PARTS & SERVICE NEWS

REF NO. AA99152

| SUBJECT: | WORKLAMP RELOCATION |
| APPLICATION: | WA500-3L Wheel Loader Serial Number A70001 thru A70621 |

Figure 1 Existing Worklamp Removal

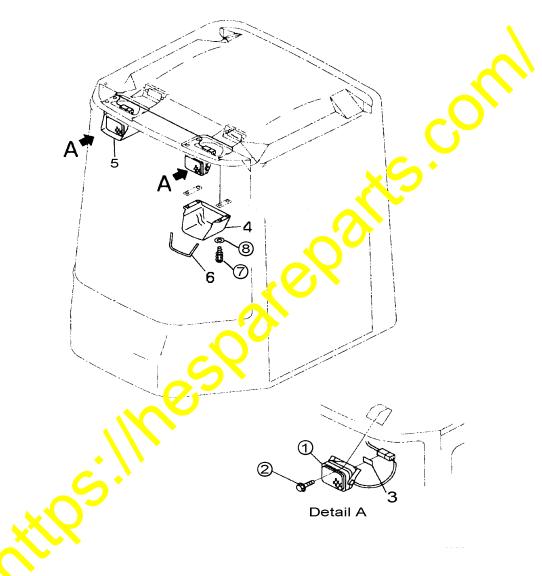
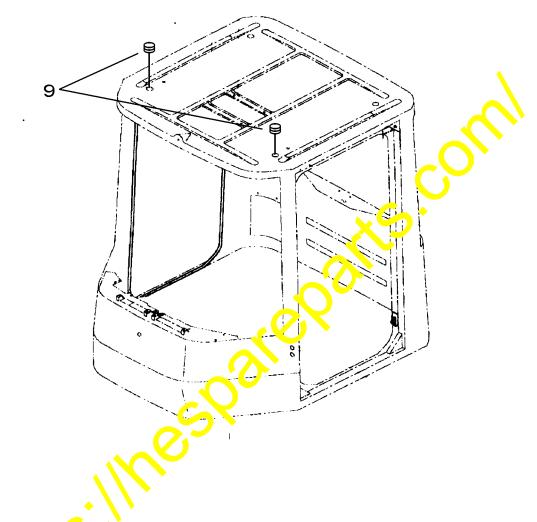
- 1. Remove screws (7), washers (8), covers (4,5) and seals (6) from worklamps.
- 2. Disconnect wire harness.
- 3. Remove bolt (2), fastener (3) and lamp assembly (1) from cab.

Figure 3 Wire Harress Installation

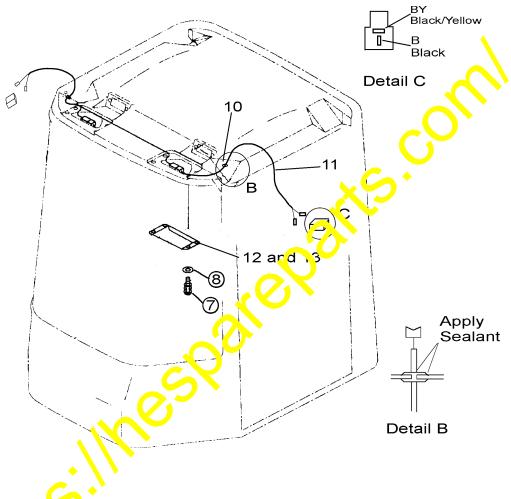
Note: Connector in Vetail C is shipped loosely and must be installed AFTER harness (11) is instand in the cab.

- 5. Install wire harness (11) through hole in cab and connect to existing harness.
- 6. As shown in detail B, place grommet (10) over harness and in hole in cab. Using threebond 5211E or equivant, apply sealant between grommet and cab and where harness comes through grommet.
- 7. Using screws (7) and washers (8), install new plates (12,13) in cab.
- 8. As shown in detail C, install loose connector on wire harness (11).

Figure 4 Worklamp Relocation

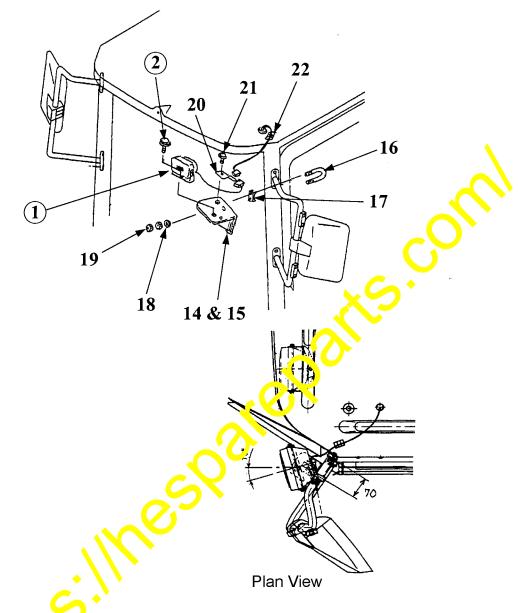
- 9. Using c bol (15) and seat (17), attach brackets (14,15) to the upper arm of the mirror stay with we see (18) and nuts (19).
- 10. Using bolt (2), install worklamp (1) on bracket and tighten to KES standards.
- 11. Using bolt (21) install clip (20) on bracket.
- 12. Connect wire harnesses and attach to clip (20).
- 13. Using clip (22), secure wire harness to cab.
- 14. As shown in the plan view, adjust worklamp away from windshield to avoid glare on the inside of the windshield.
